SUPPLEMENT

IN RESPONSE TO CEC DATA ADEQUACY REVIEW APPLICATION FOR CERTIFICATION (09-AFC-01)

for Watson Cogeneration Steam and Electric Reliability Project

June 2009

ELECTRICAL ONE LINE DIAGRAM
OVERALL
FIGURE D-3

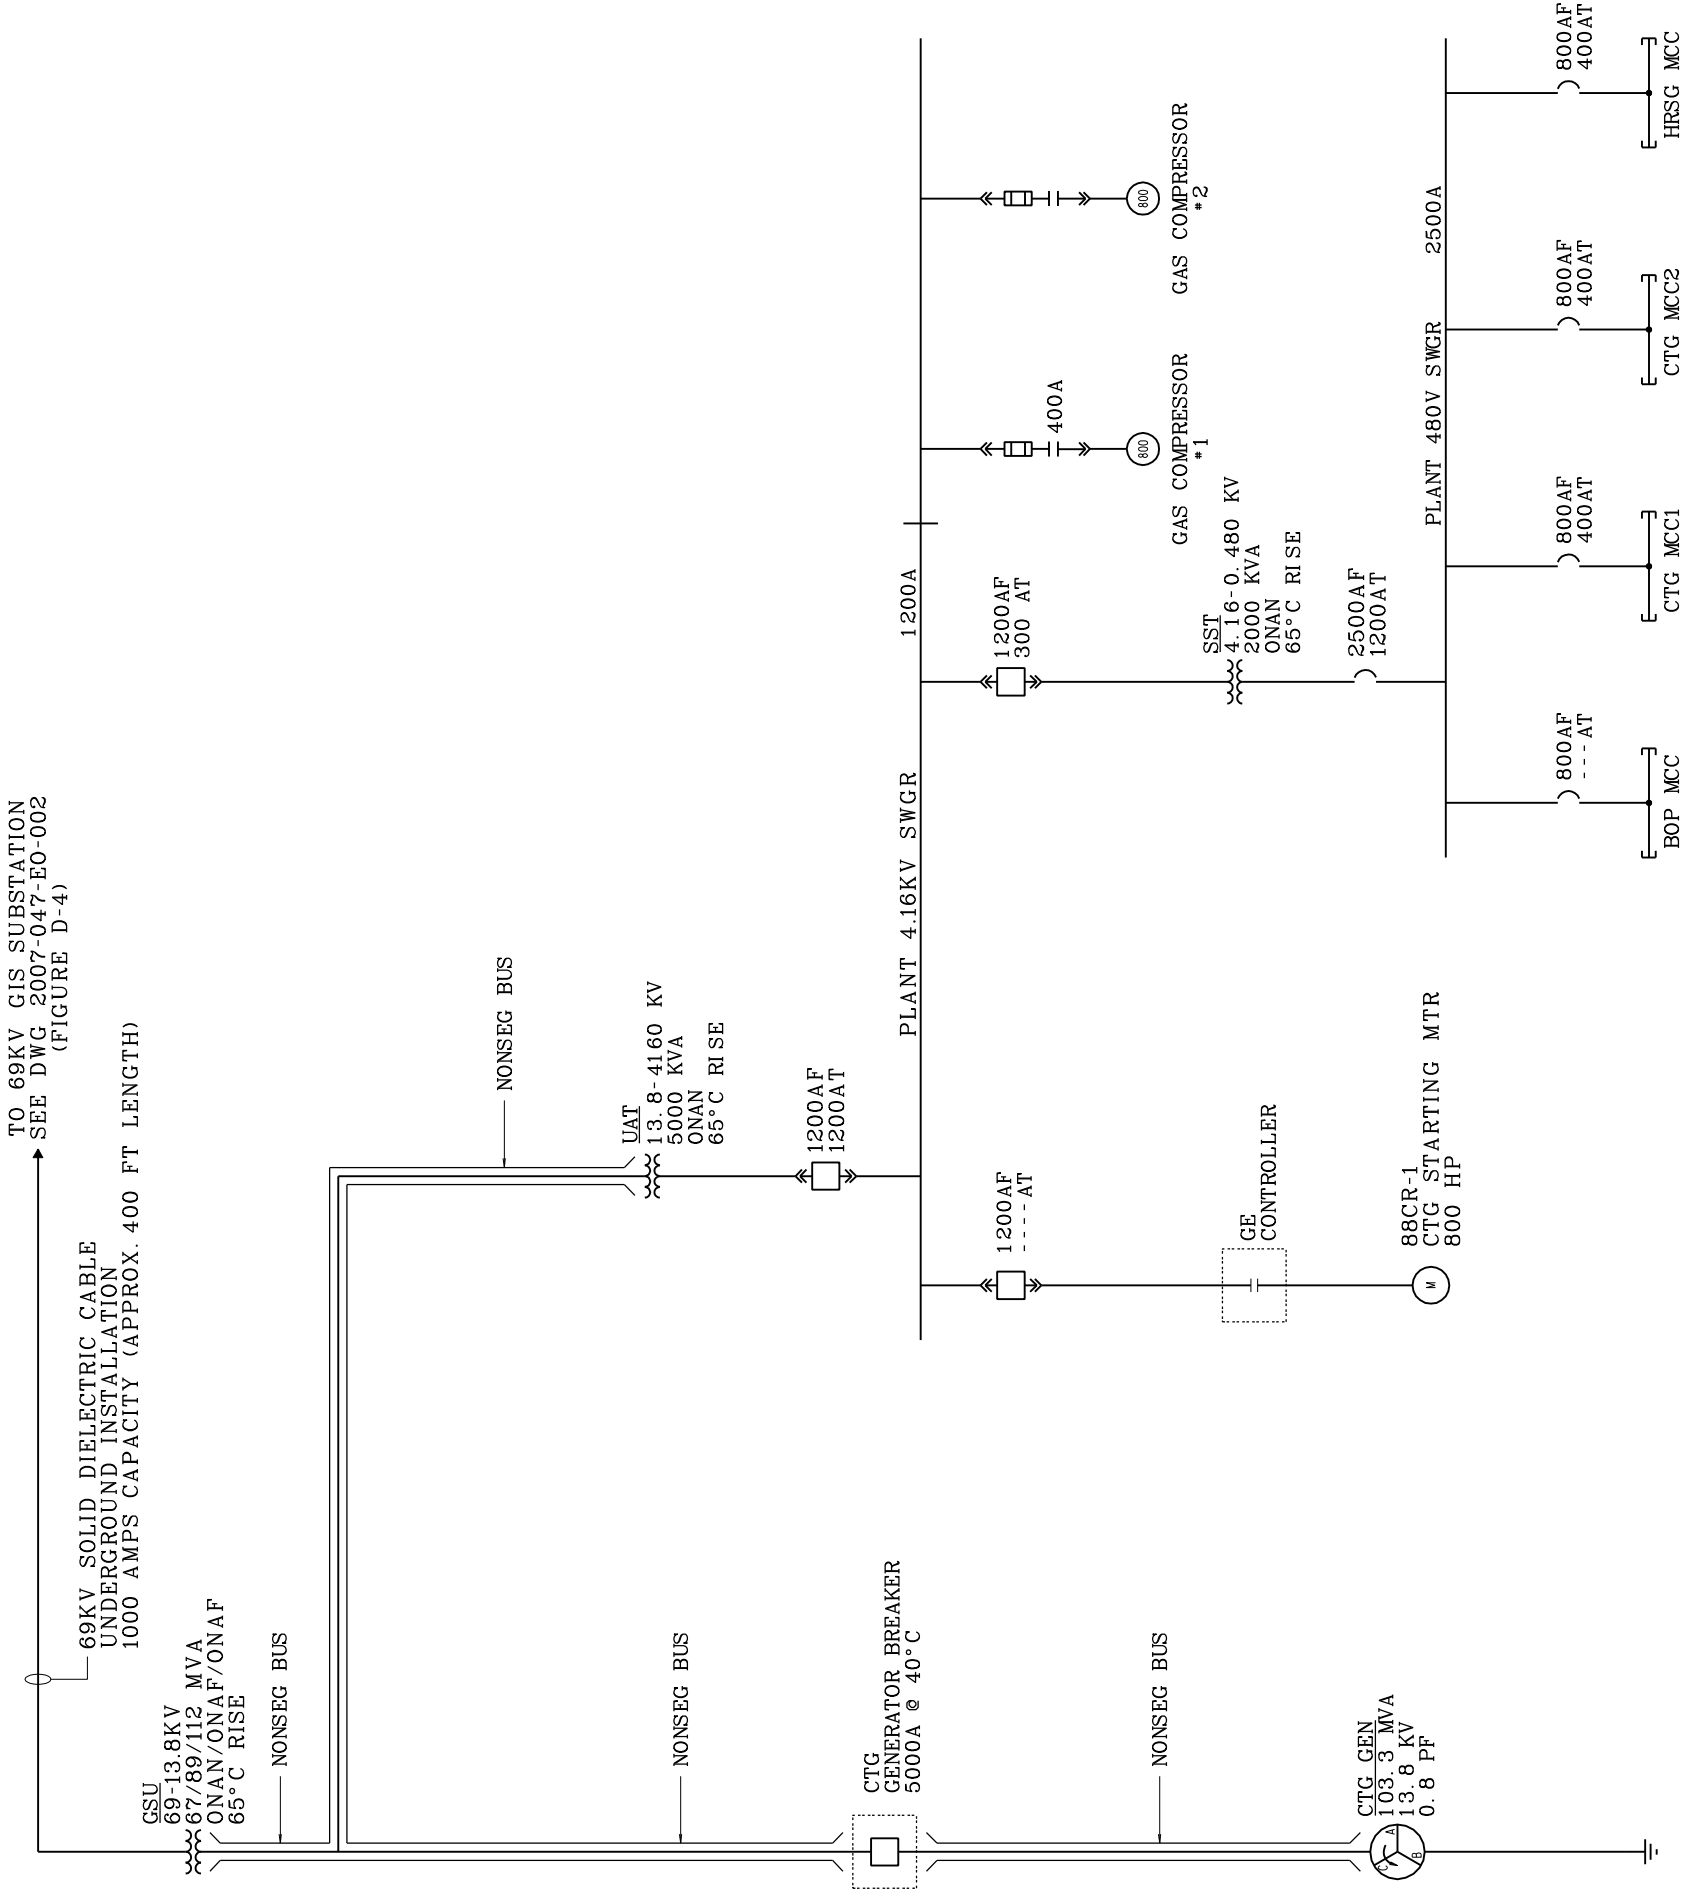
COMMENT NUMBER	SITING REGULATIONS	INFORMATION	INFORMATION REQUIRED TO MAKE AFC CONFORM WITH REGULATIONS	RESPONSE
7a	Appendix B (b) (2) (C)	A detailed description of the design, construction, and operation of any electric transmission facilities, such as power lines, substations, switchyards, or other transmission equipment, which will be constructed or modified to transmit electrical power from the proposed power plant to the load centers to be served by the facility. Such description shall include the width of rights of way and the physical and electrical characteristics of electrical transmission facilities such as towers, conductors, and insulators.	1. Provide a one-line diagram for the existing 230kV GIS switchyard after interconnection of the project. Show proposed bay arrangements of the equipments with ratings such as breakers, disconnect switches and relays, etc. which are required to interconnect the project. 2. Resubmit Figure 3-12 (Electrical One Line Diagram) with the breaker ratings, disconnect switches and relay details of the proposed new 69kV GIS substation. [Continued on next page]	1. The 230kV GIS switchyard is owned by SCE, not by the Applicant. A point of contact for SCE was provided to the CEC at the CEC's request. For the 230kV system, Figure D-1 (230V System Overall One-Line Diagram), Figure D-2 (Breaker Ratings) and the following ownership description are provided as reference. The SCE switchyard is the outdoor 230kV interconnection between the overhead lines and the gas insulated substation. This transition contains a dead end structure, line disconnects and grounds, PT's and CT's, wave traps and the bushings for connection of the gas insulated bus to un-insulated conductor. All line protective relaying is also part of the SCE switchyard, yet they are housed in the building. The point of connection of the gas insulated bus to the un-insulated conductor is the dividing point between Watson and SCE. The Watson substation, consists of the circuit breaker, associated disconnect and ground switches and all protective relaying for the loads. The substation is housed in a metal building. [Continued on next page]

Figure 5.5-1 (Revised)
Water Balance Flow Diagram

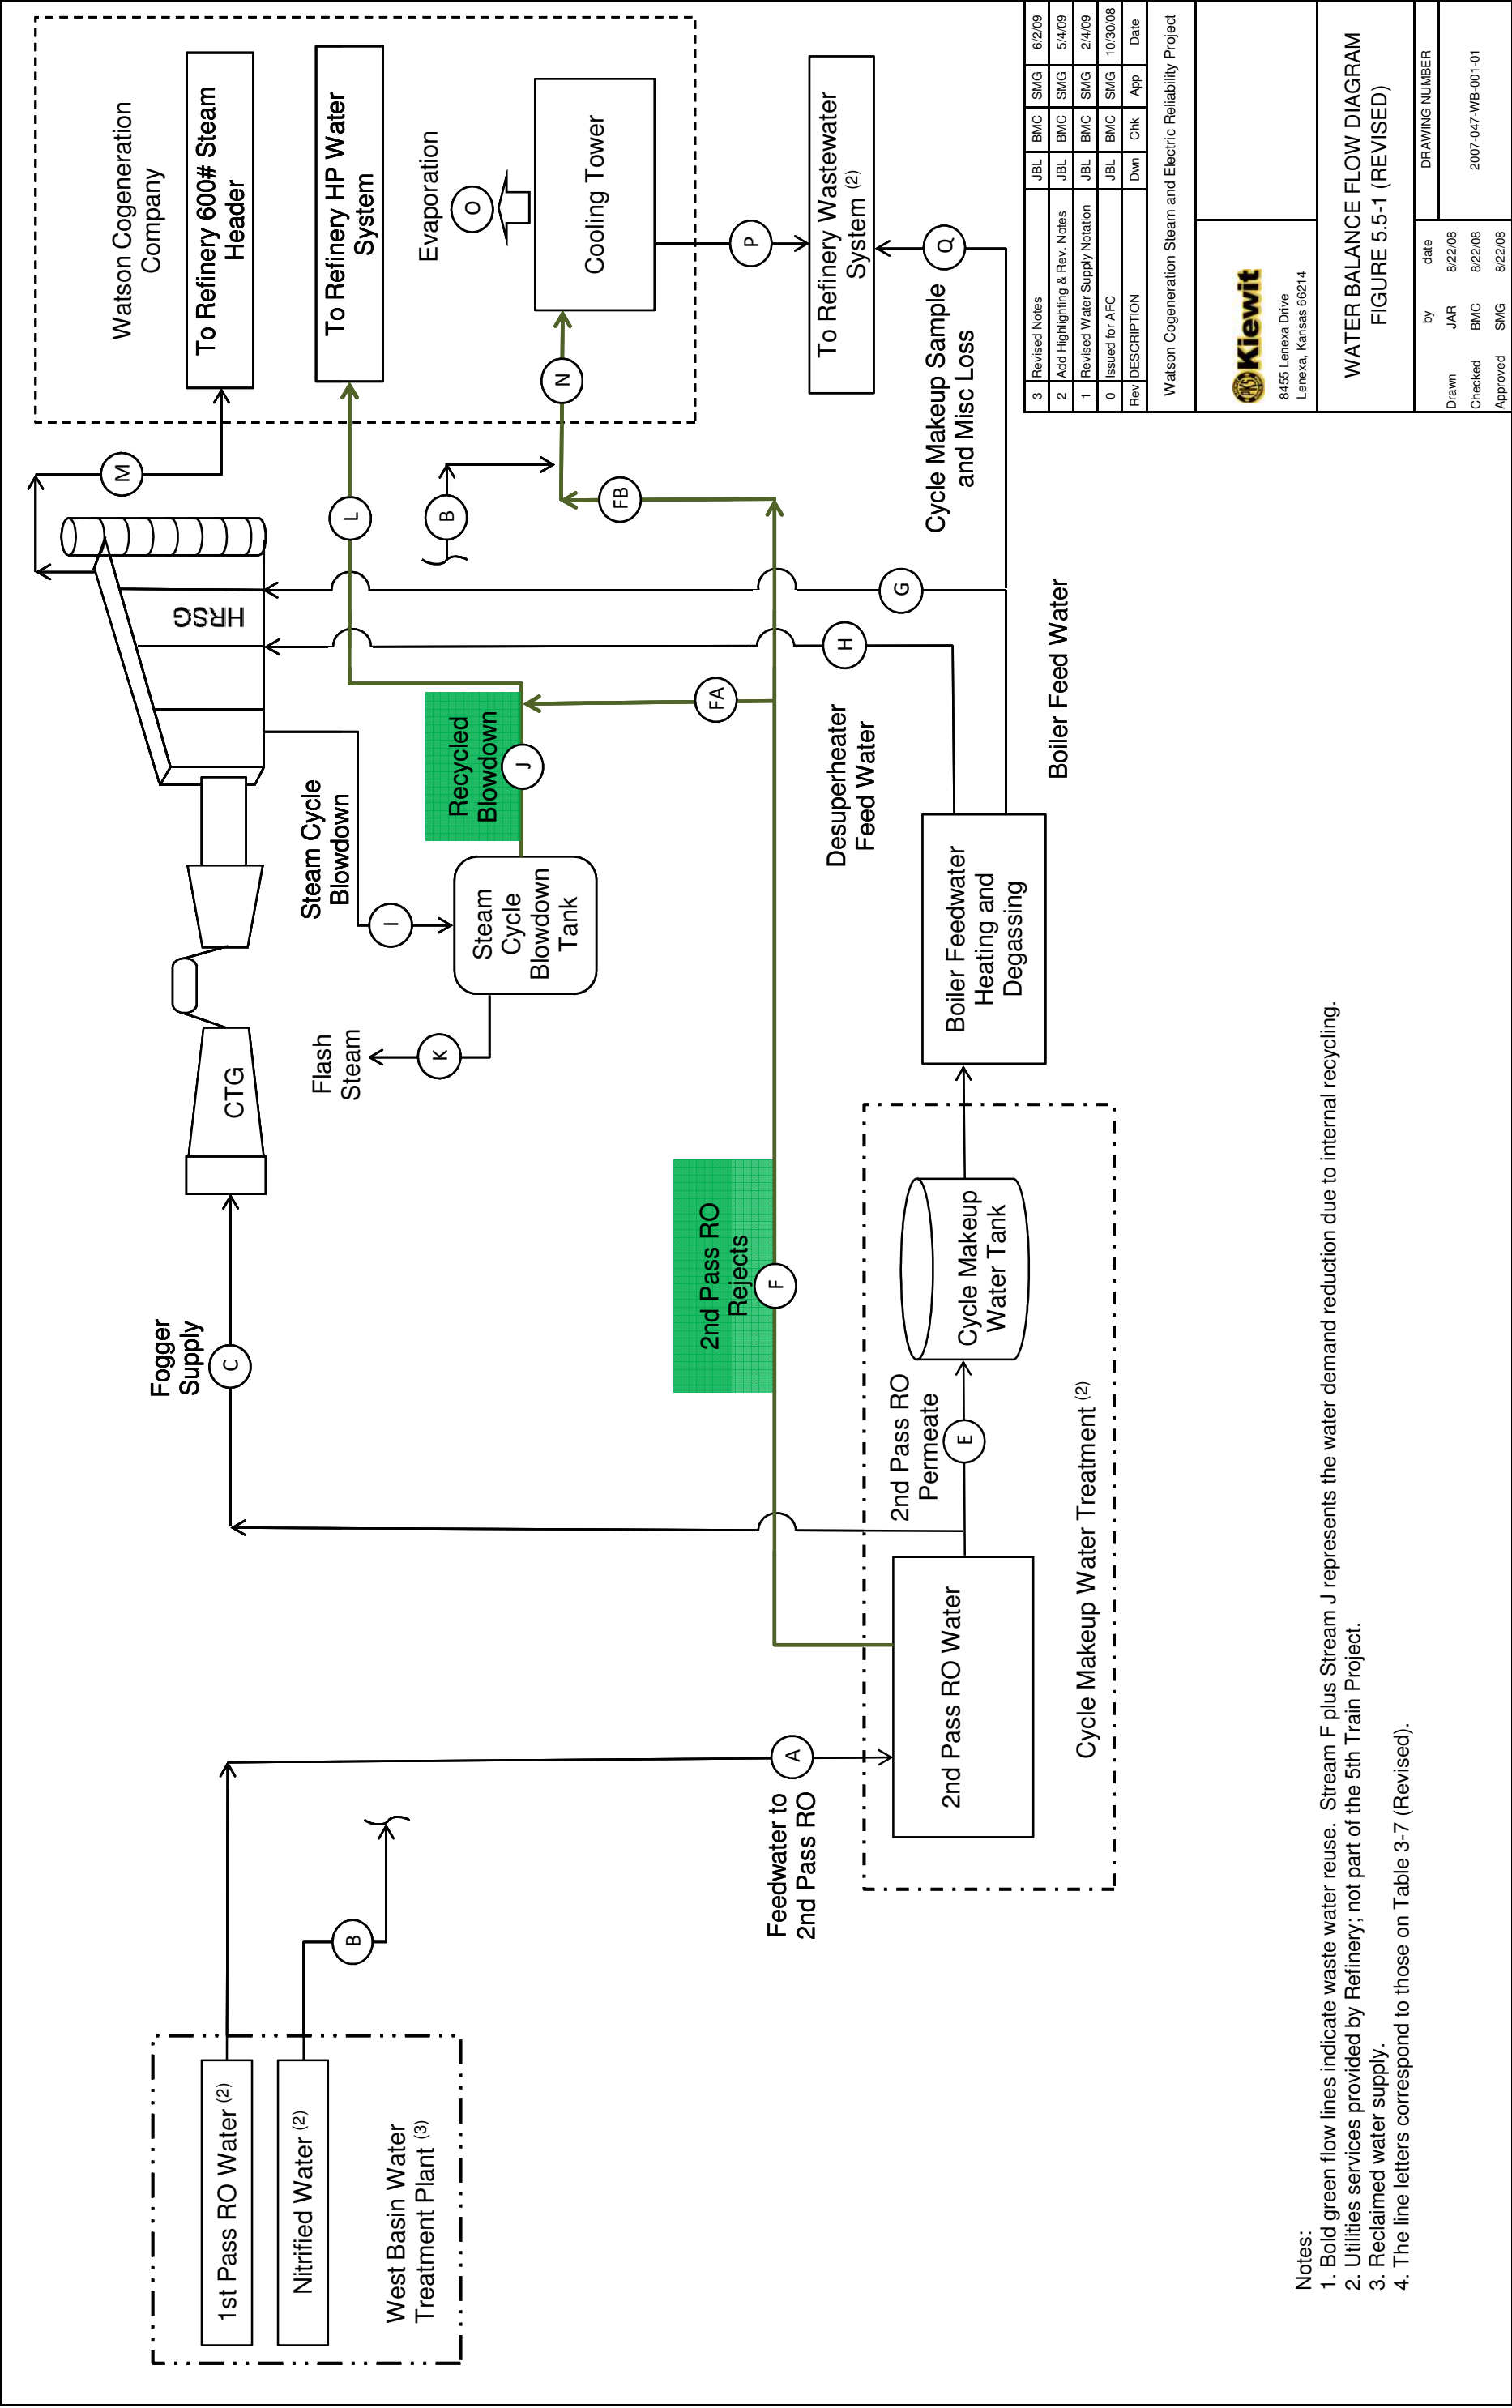
COMMENT NUMBER	SITING REGULATIONS	INFORMATION	INFORMATION REQUIRED TO MAKE AFC CONFORM WITH REGULATIONS	RESPONSE
9b	Appendix B (g) (14) (C) (vii)	Provide water mass balance and heat balance diagrams for both average and maximum flows that include all process and/or ancillary water supplies and wastewater streams. Highlight any water conservation measures on the diagram and the amount that they reduce water demand; and	Heat balance diagrams were not provided. These are needed for both average and maximum flows. Also, the water flow diagrams need to be revised to include both average and maximum flows. Water conservation measures need to be highlighted on these diagrams.	Section 3.4.5 in the AFC stated that the "inputs and outputs corresponding to this process flow diagram are presented in Table 3-2..." To clarify the information, the heat balance diagram [Figure 3-11 (Revised) in Appendix F of this AFC Supplement] has been revised to present labels on the various process streams that cross-reference to Table 3-2 (Revised) (also in Appendix F of this AFC Supplement). Average values and maximum values for cases with and without duct firing have been added to Table 3-2 (Revised). The primary water conservation measure will be the use of reclaimed wastewater that would otherwise be discharged to the ocean. In addition, this water supply is further conserved by reuse of internal waste streams for cooling tower makeup. The water balance diagram has been revised to clarify water conservation measures by highlighting in green the reclaimed water supply and the reuse of internal wastewater streams. The diagram is presented as Figures 3-13 (Revised) and 5.5-1 (Revised) in Appendix F of this AFC Supplement. They are identical figures that originally appeared in the AFC Project Description and Water Resources sections, respectively. The streams have been lettered to correlate with Table 3-7 (Revised). This revised table includes the addition of rows that quantify the internal recycling of water.
